# UNITED STATES PATENT AND TRADEMARK OFFICE

APPLICATION NO.	FILING DATE	FIRST NAMED INVENTOR	ATTORNEY DOCKET NO.	CONFIRMATION NO.
10/662,870	09/15/2003	Neal Tate Saiki		2145
7590	02/03/2006		EXAMINER	
Neal Saiki 111 Bean Creek Road Unit 26 Scotts Valley, CA 95066-4136				WINNER, TONY H
			ART UNIT	PAPER NUMBER
			3611	
DATE MAILED: 02/03/2006

<b>Office Action Summary</b>	<b>Application No.</b>	<b>Applicant(s)</b>	
	10/662,870	SAIKI, NEAL TATE	
	Examiner Tony H. Winner	Art Unit 3611

## DETAILED ACTION

*Attachment***FIG. 6****FIG. 7**

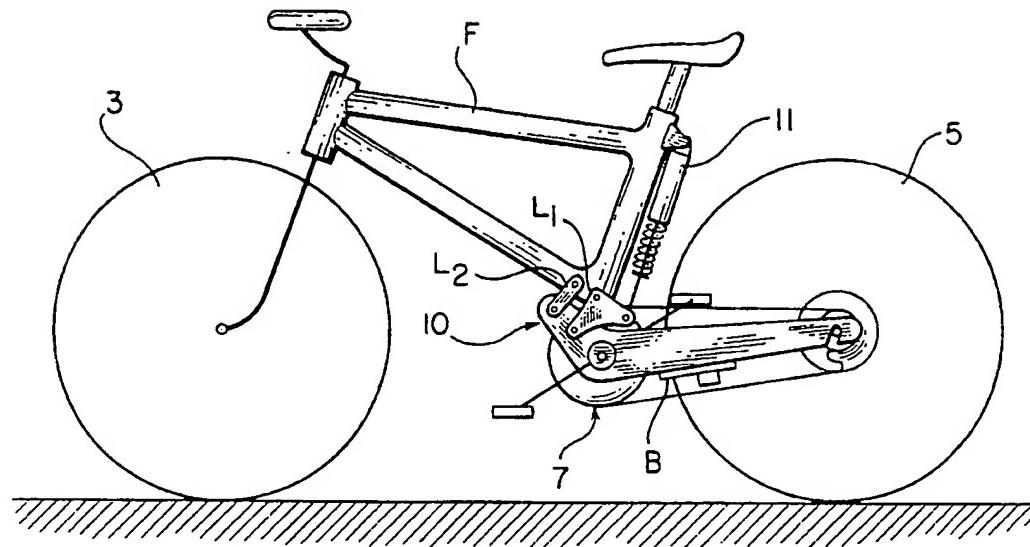
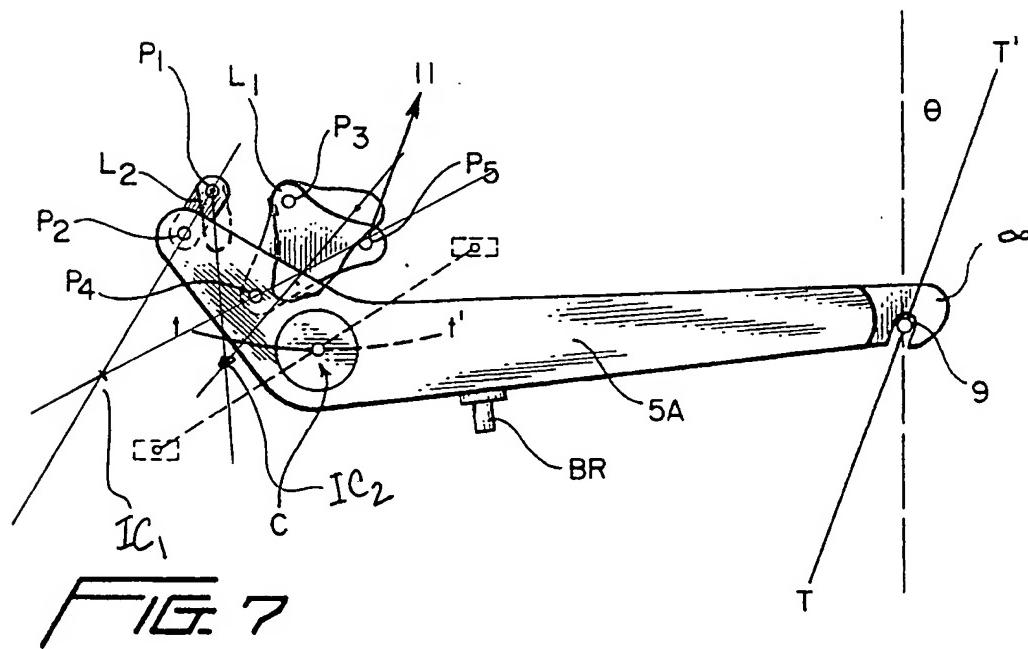
Harris discloses all of the structural of a rear suspension for a bicycle, the suspension comprising:

- a) a main frame (F),
- b) a shock absorbing means (11),
- c) a swingarm (SW) that moves relative to the main frame,
- d) a bicycle rear wheel attached to said swingarm,
- e) a crank assembly (figure 7) attached to said swingarm, and
- f) a linkage means (L1 and L2) for connecting said swingarm to said frame,

g) said swingarm has an instant center of rotation that moves as the swingarm moves from the uncompressed to fully compressed state, the instant center of rotation is horizontally located forward of the crank assembly center when the swingarm is uncompressed and moves significantly rearward as the suspension is compressed, thus, thus reducing in the vertical movement of said crank assembly as the swingarm is moved from the uncompressed to compressed position (see attachment).
